From: Wooldridge, John
Sent: Friday, June 5, 2020 11:08 AM
To: 'jhoward@wearehls.com'; 'choward@wearehls.com'
Cc: Heim, Kimber; Norton, Harvey
Subject: 110412 FAI 037 Safety Project D5 Requests Cost Proposal ASAP
Attachments: 110412 FAI 037 Preliminary RW with all sheets.pdf; 110412 FAI 037 Cost Proposal 34127 HLS 060520.xlsx

Subject: RE: FAI-37-6.34 Preliminary Right of Way Plans (PID No. 110412)

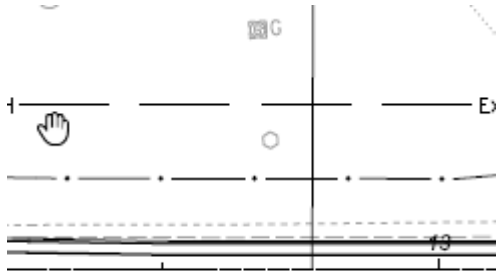
- Missing sheet 20 of 37 as Luke stated.
- Page 21/36 (22/37) Parcel 11-SH shows "Utility Pole Save" for private light poles. I would have them removed as ODOT will need to pay for them anyways (in take area) and would need to do a permit (not recommended) for the poles that are very close to the fence needing removed. Same Parcel has three of those poles (not 2) and also has a small sign near the fence that was not picked up on these plans:
